**ADDENDUM NO. 1**

**CID 01-STILLHOUSE BRANCH WASTEWATER TREATMENT FACILITY  
IMPROVEMENTS**

**PROJECT NO.: 2-01590 | TWDB CWSRF NO. 73776**

**DATE OF ADDENDUM: MAY 24, 2023**

DRAWING NO.  
**P-05**

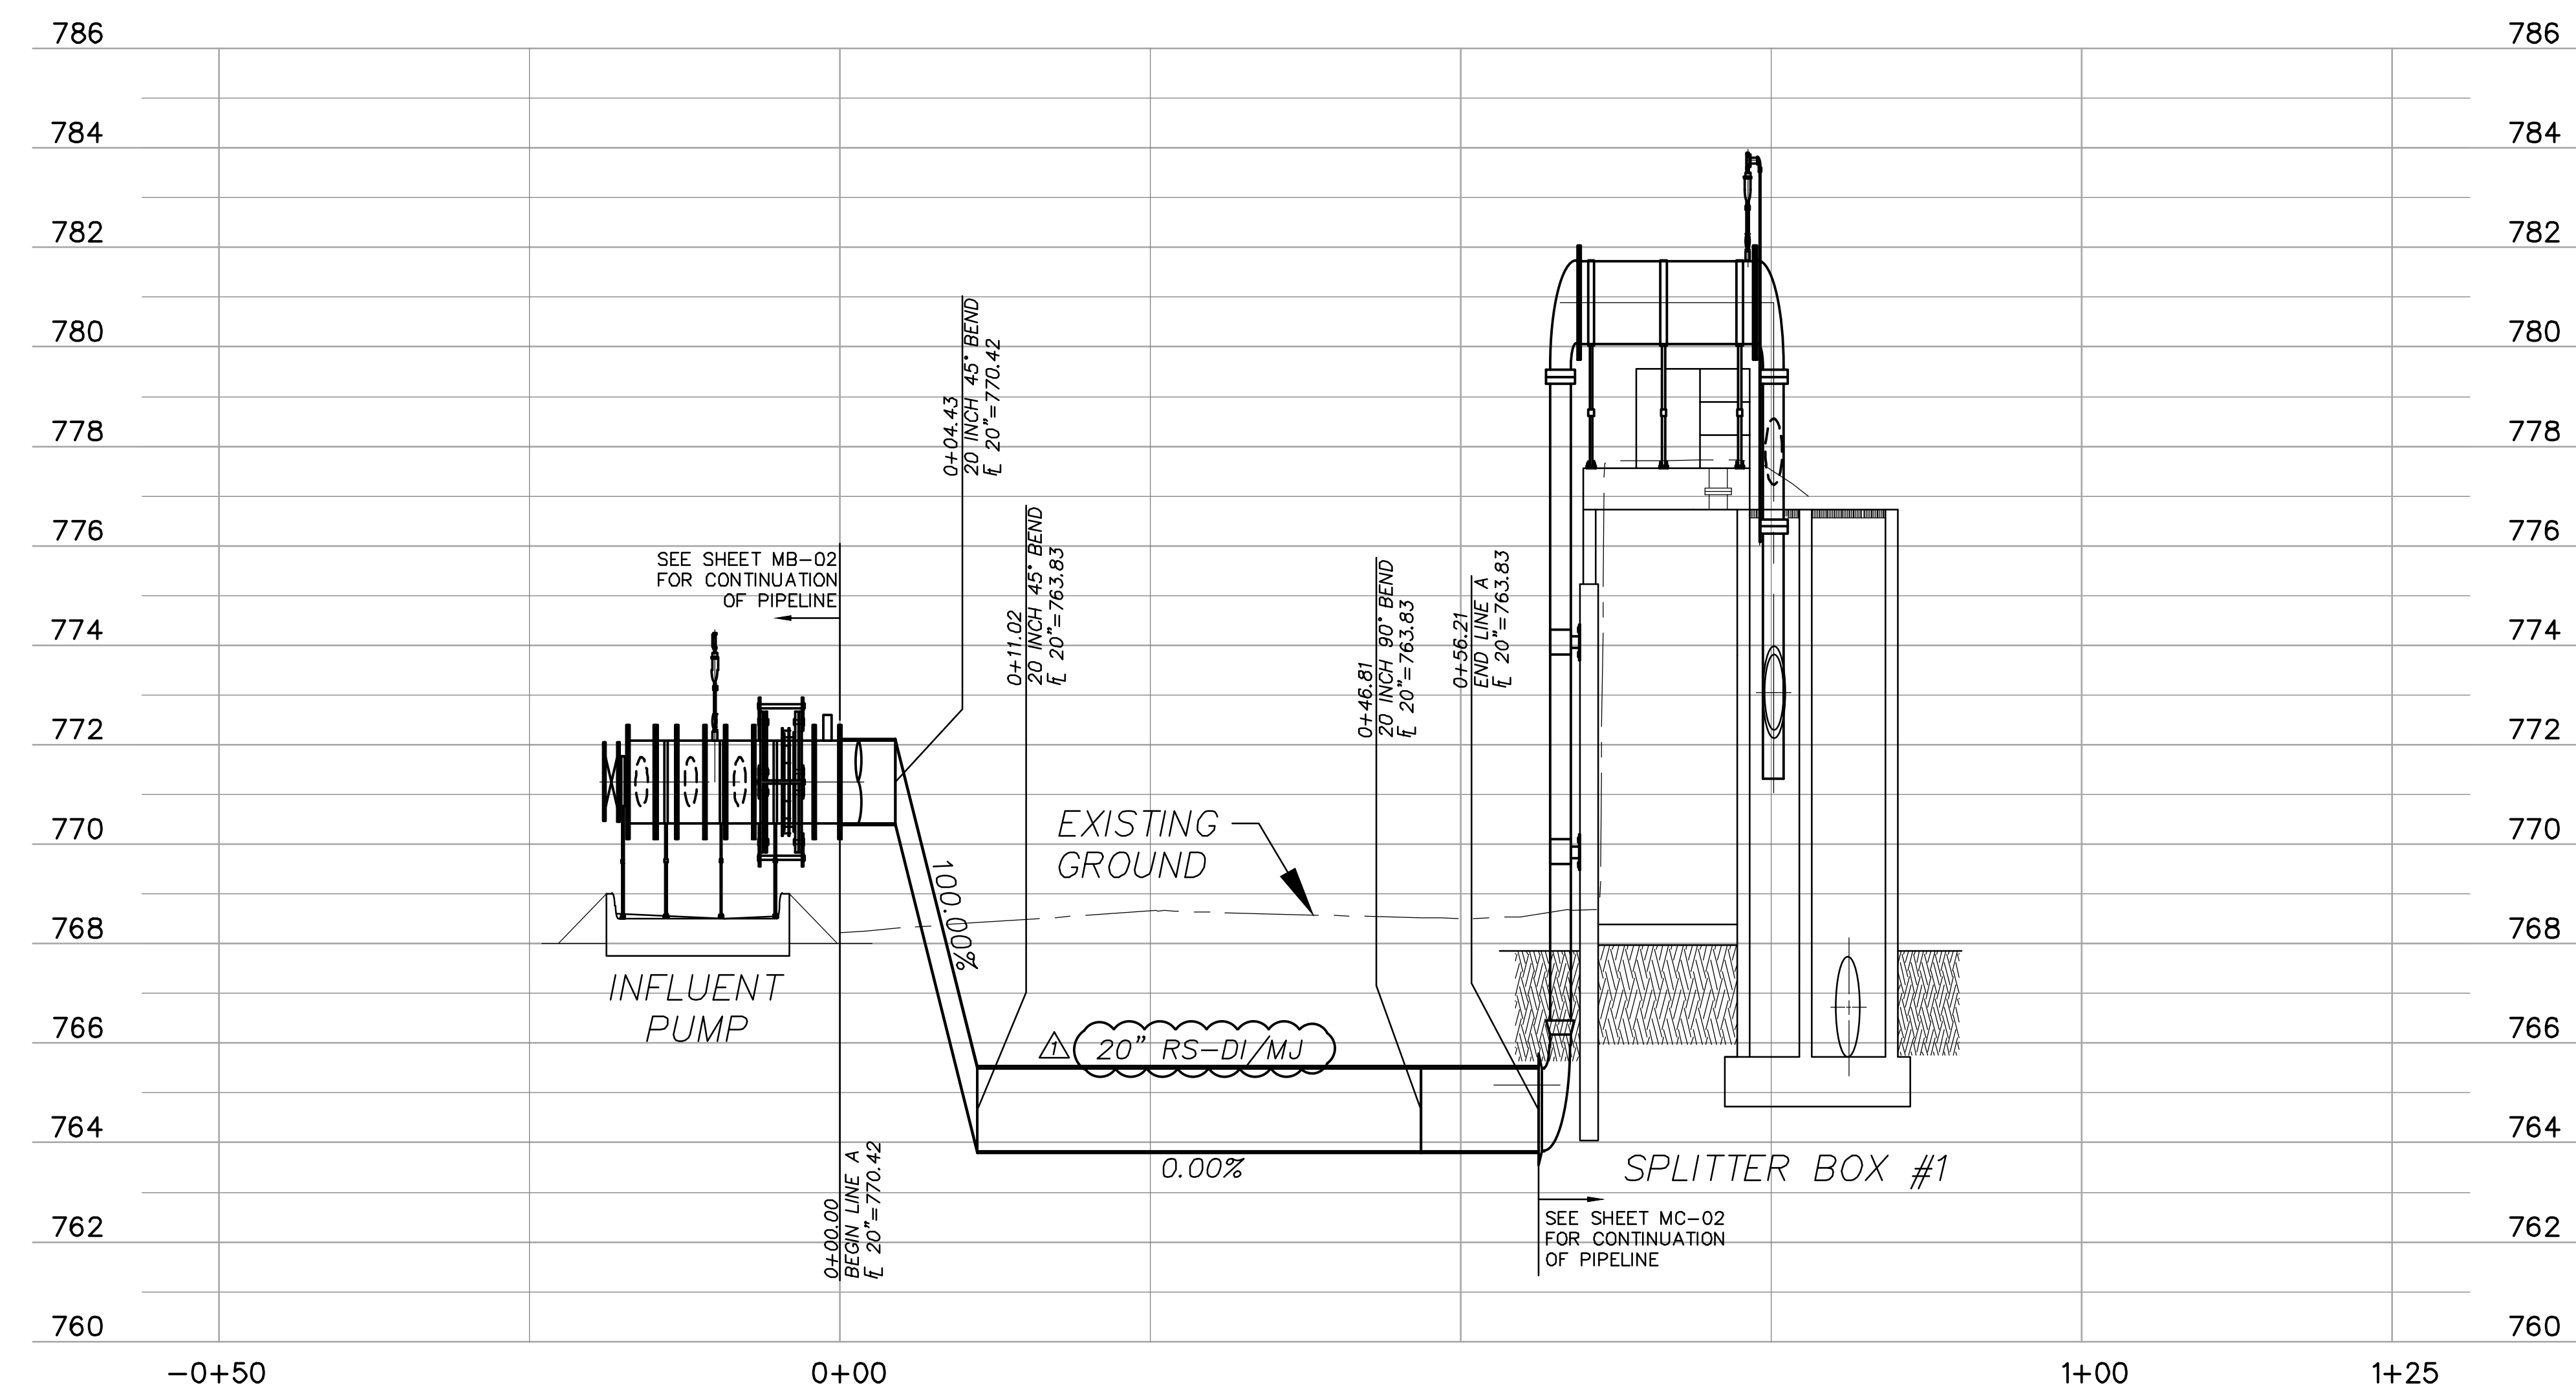
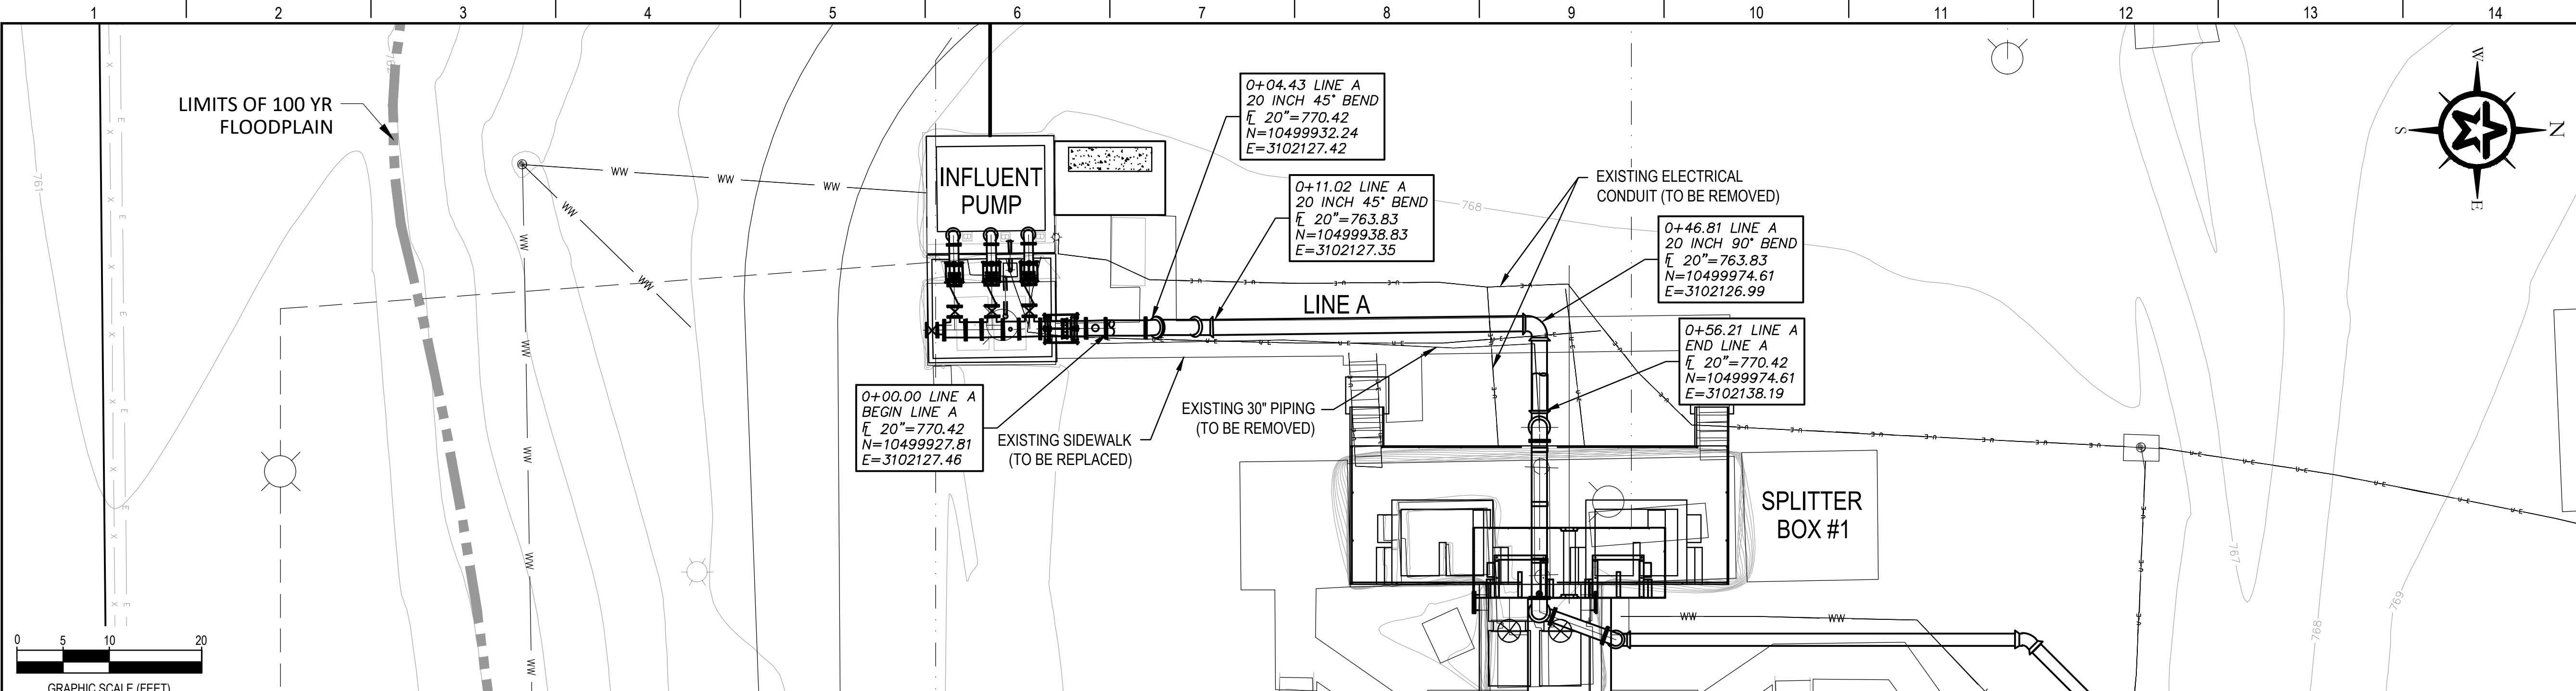
c. Sheets P-01 through P-05

REVISE to match the yard pipe labels.

DESIGNED	J. JENKINS
DRAFTED	M. CLOUGH
CHECKED	TFG, PA
PROJECT NO.	J. JENKINS
	2-01590
DRAWING NO.	
	C-08

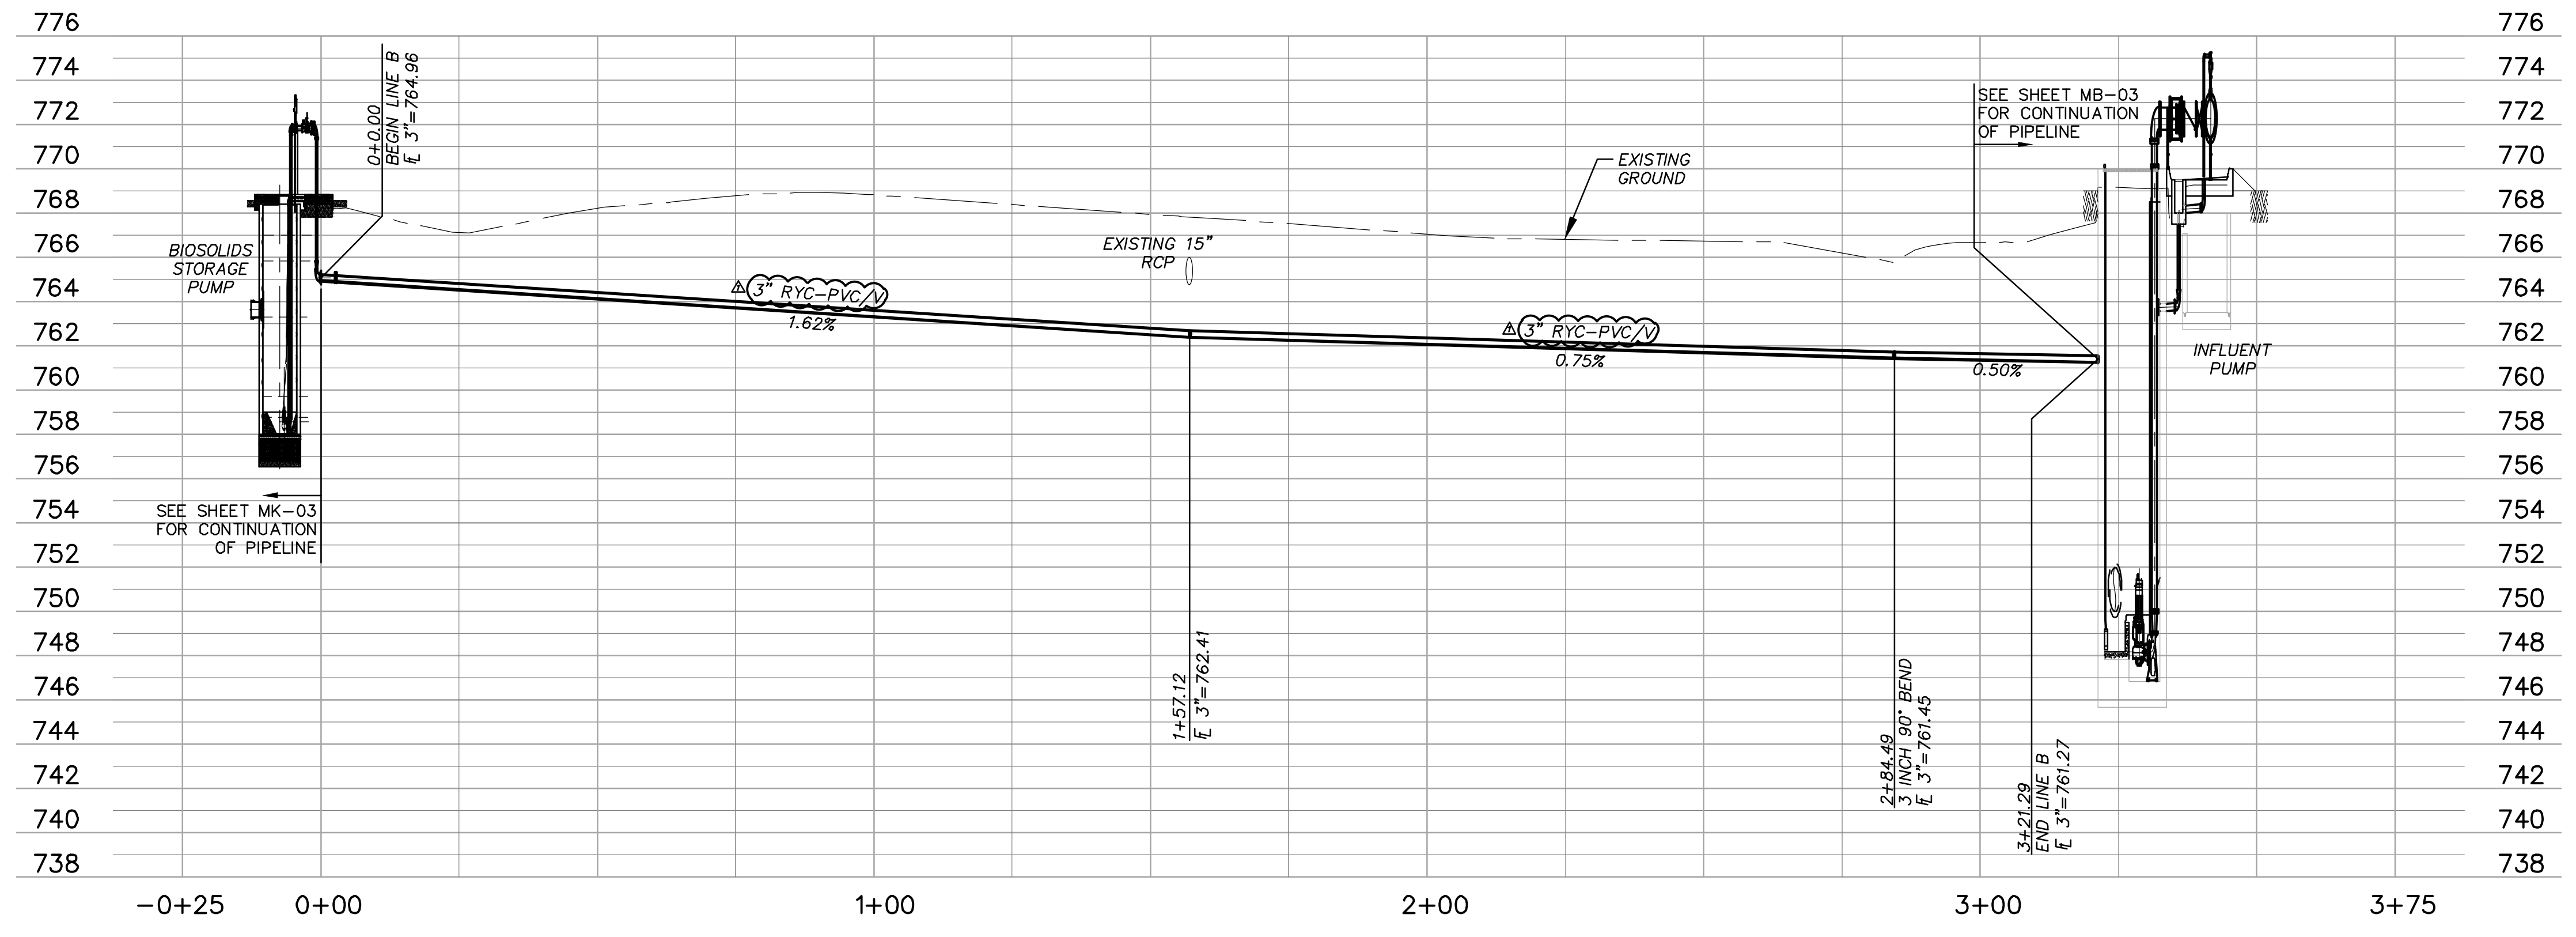
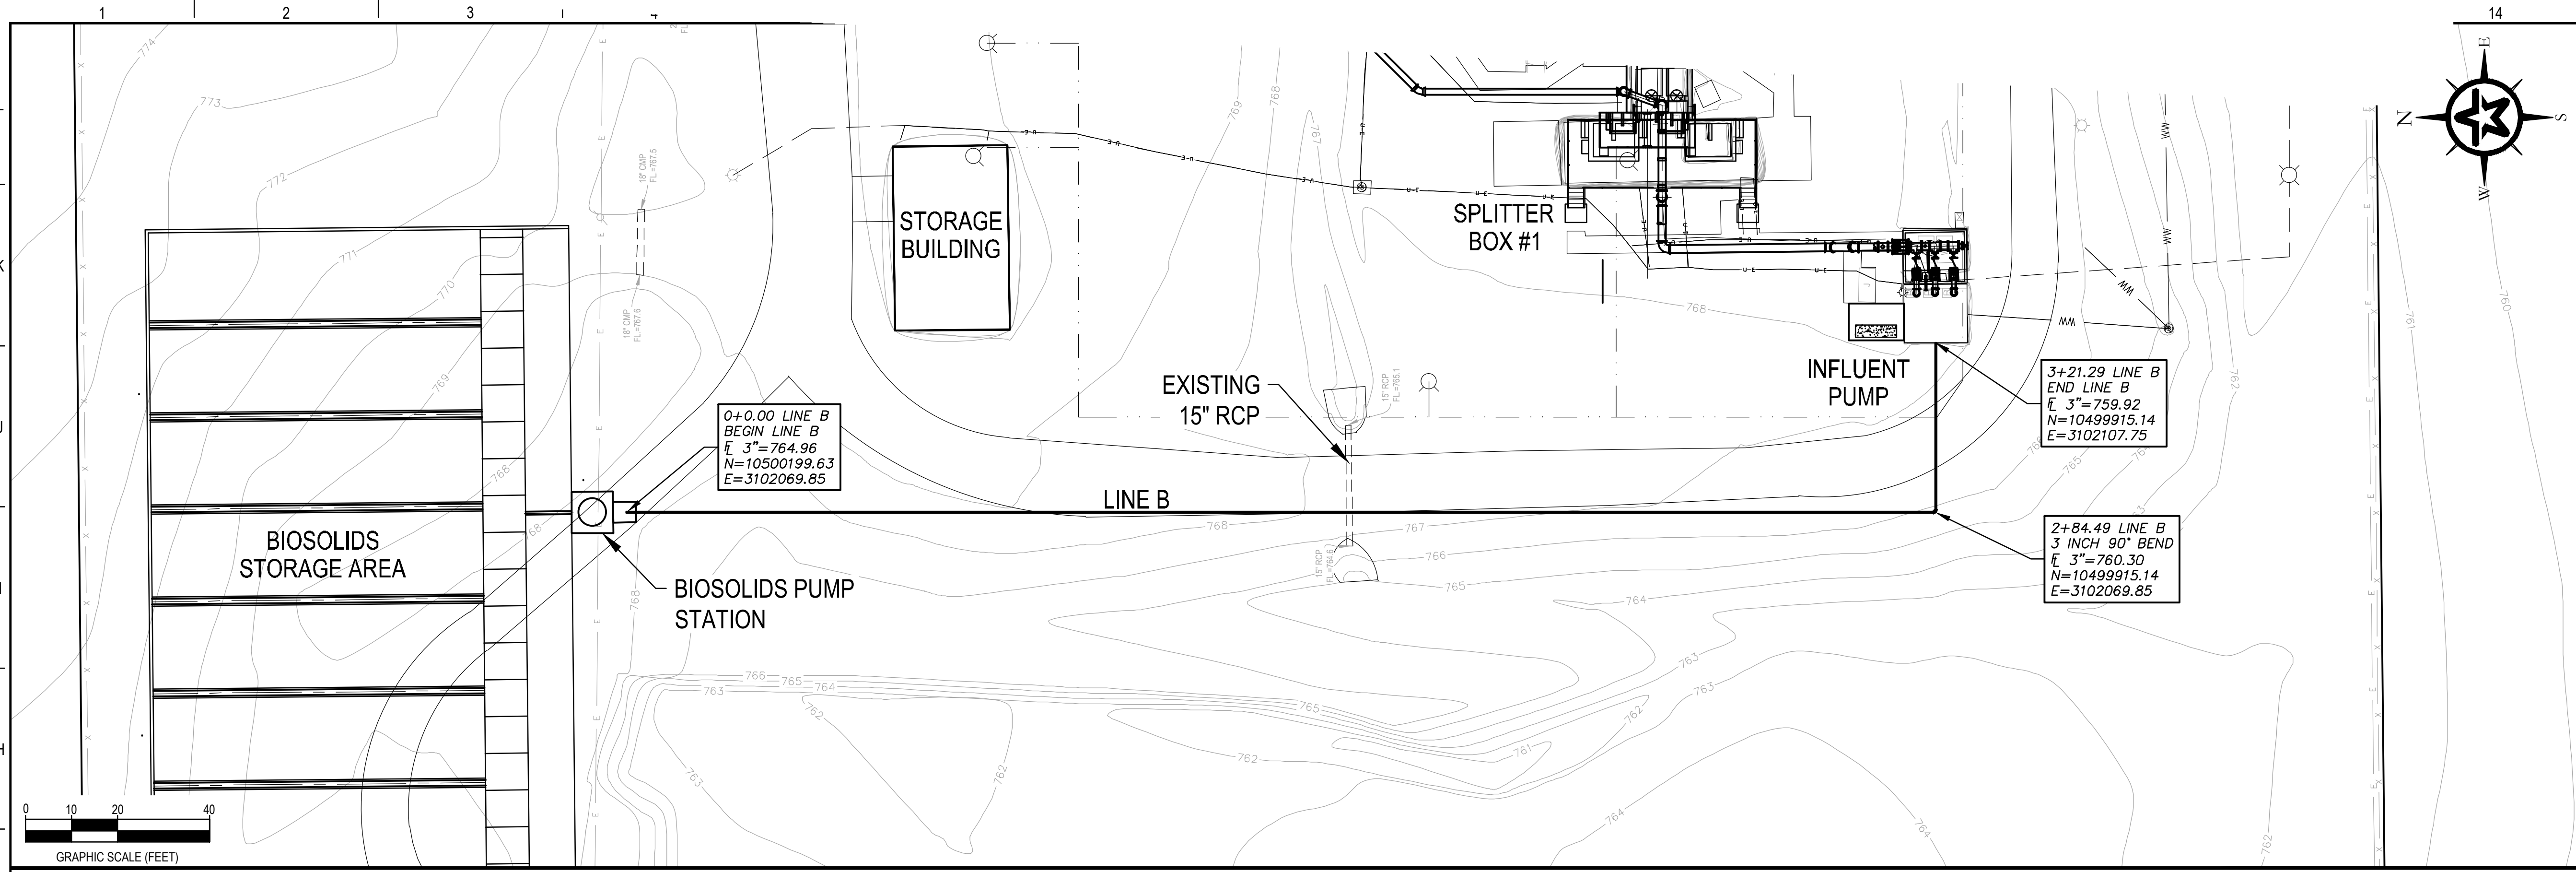
a. Sheets C-08 through C-17

REVISE yard piping to reflect the pipe labels on Sheet M-01 and Sheet M-02.
